# Access Compliance Report

## Public Rights-of-Way

Intersection ID: 29153	Main Street: BRIAR_ROSE_CT	Cross Street: HIGHLAND_PARK_DR	Location: N
ADA ID: FC54765C2910	Ramp Type: PerpDiag	Initial Pass/Fail: Pass	Overall Compliance: No
Severity Score: 7.75			
Codes/Mitigation Info/Possible Solution		Field Measurements/Component Compliance

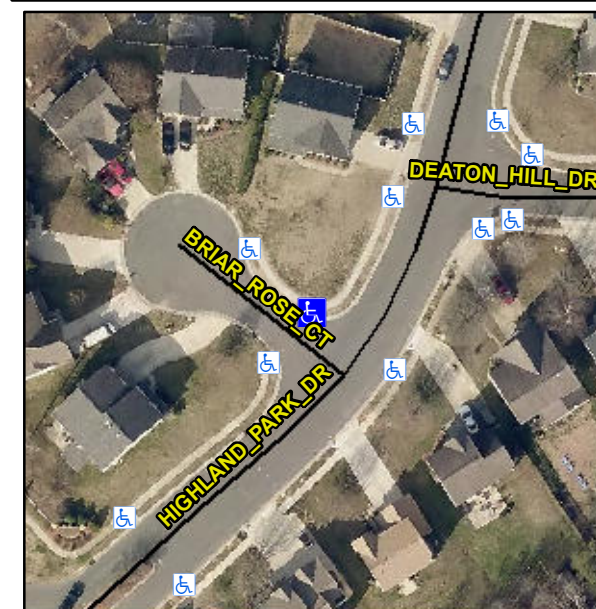
**R304.5.3, R304.2.1, R305.1.4, R305.2, R302.7.2**

Compliance	Description	Data	Compliance	Description	Data
N/A	Ramp Length (in)	47.0	Yes	Ramp Slope (%)	6.0
Yes	Ramp Width (in)	48.0	No	Ramp XSlope (%)	2.2
N/A	Flare Type LT	Sloped	N/A	Flare Type RT	N/A
N/A	Flare Slope LT (%)	4.6	Yes	Flare Slope RT (%)	9.8
N/A	Flare Traversable LT?	Yes	N/A	Flare Traversable RT?	Yes
No	Landing Length (in)	47.0	Yes	DWS Provided?	Yes
Yes	Landing Width (in)	48.0	Yes	DWS Contrast?	Yes
Yes	Landing Slope (%)	0.8	No	DWS Length (in)	23.0
No	Landing X Slope (%)	2.8	Yes	DWS Full Width?	Yes
N/A	Landing Curb? (Y/N)	No	No	DWS Offset (in)	2.5
N/A	Shared Landing?	No			
Yes	Gutter Ponding?	No	Yes	Gutter Slope (%)	2.9
No	Gutter Lip Ht (in)	0.5	Yes	Gutter X Slope (%)	0.7
N/A	Painted X Walk1?	No	N/A	Painted X Walk2?	No
	X Walk 1 Direction	To SW		X Walk 2 Direction	To SE
N/A	X Walk 1 Width (in)	N/A	N/A	X Walk 2 Width (in)	N/A
	X Walk 1 Slope (%)	0.9		X Walk 2 Slope (%)	1.2
	X Walk 1 X Slope (%)	15.0		X Walk 2 X Slope (%)	0.9

N/A	Ramp inside XWalk1?	N/A	N/A	Ramp inside XWalk2?	N/A
	Road Slope (%)	1.9	N/A	Clear Space?	Yes
	Road X Slope (%)	0.9	N/A	Clear Space to XWalk (in)	N/A
Yes	Any Obstructions?	No	Yes	Storm Grate/Utility Hazard?	No
	Obstruction Type			Storm Grate/Utility Type	
		N/A			N/A
			Yes	Surface Condition? (G/P)	Good

**Remove & Replace Curb Ramp With Two New Directional Ramps or Equivalent. Grind Gutter Lip.**
